STAFF RECOMMENDATION

1410 Dallas Avenue

February 17, 2021

Application: New Construction-Addition

Figure 3. Right side: existing addition steps wider

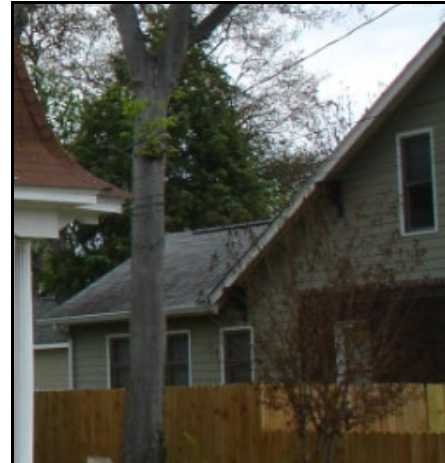
Demolition: On the right, where the existing one-story addition steps wider than the house, there is currently a door facing the street. (Figure 3) The applicant proposes to fill in this door so there is a solid brick wall; this is considered partial demolition. Staff finds this to be appropriate as the addition is non-historic. The wall is only five feet (5') wide and does not require an opening. The brick and mortar used to infill this opening should match the existing as closely as possible.

The new addition will not step any wider than the existing addition on the right side. Here, the existing addition steps five feet (5') wider than the main body of the historic house (Figure 3) On the first level, the addition will be inset slightly (about one foot (1')) to avoid any setback issues. Because there is an existing addition, the applicant is not required to provide an inset at this corner.

Figure 6. Rear elevation

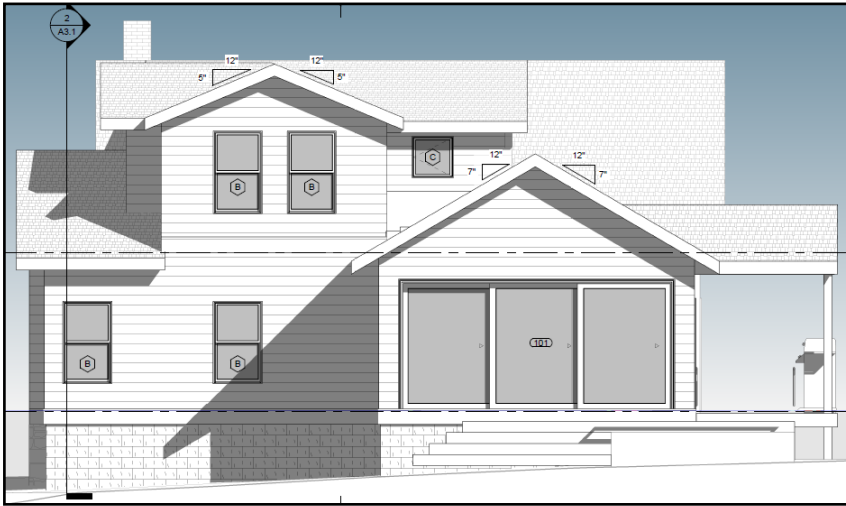
Roof form: The addition uses two rear-facing gables: one that has a 7/12 pitch and extends the existing one-story addition on the left side of the house and the second is 5/12 and is at the second level.

Figure 7. Left side elevation.

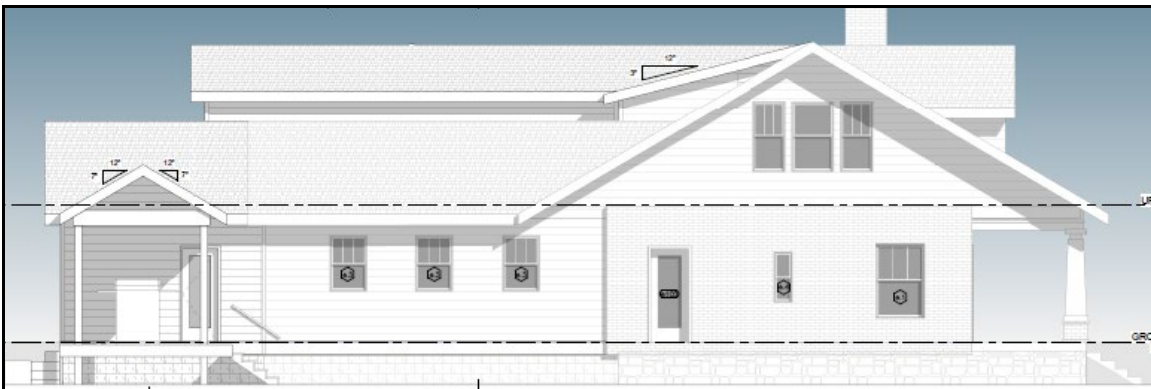
On the left side, the existing addition was constructed flush with the historic side wall. (Figure 4). Because the historic corner has already been obscured and because the proposed addition in this location is only one story high and one room deep, at about fourteen feet (14'), staff finds that an inset is not necessary in this location.

While the side wall of the addition is flush with both the existing addition and the historic house, an open side porch will step wider. The guidelines state that: *Rear additions that are wider than an existing historic building may be appropriate when the building is narrower than 30' or shifted to one side of the lot.* Staff finds the wider addition to be appropriate in this case because the house is shifted on the lot (the original house sits

Figure 8. Right side elevation.

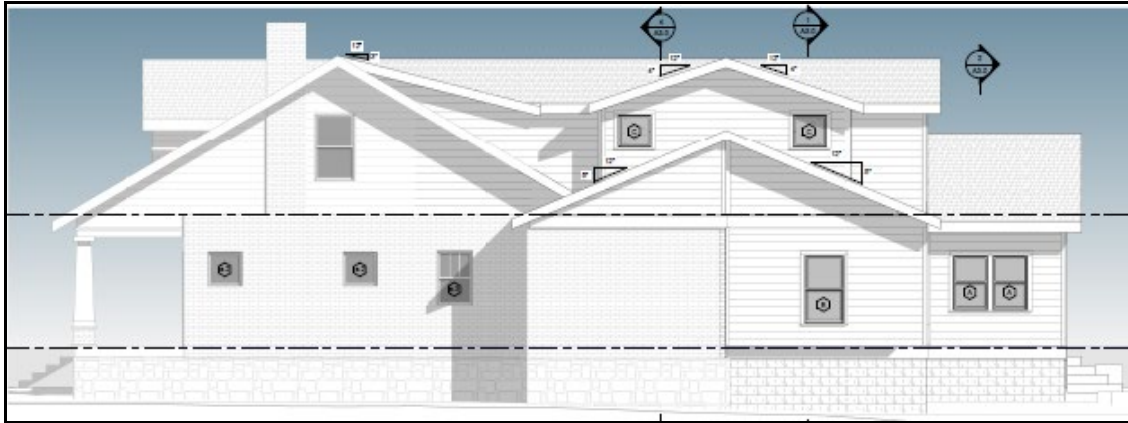
Where the old shed-roofed addition steps wider on the right side, the applicant proposes to alter the roof form, creating a 5/12 gable facing the side property line. (Figure 8) Another gable with a 4/12 pitch will extend above.

proposed for the second level on the left side. (Figure 8) Staff finds that these could be appropriate in this location as they are accent windows, not the dominant window form.

On the right-side elevation, there is a fifteen-foot (15') section of brick wall with no window. The guidelines recommend a window or door opening every eight to thirteen feet (8'-13'). Because this wall is existing, staff is not recommending a window be added to the masonry wall.
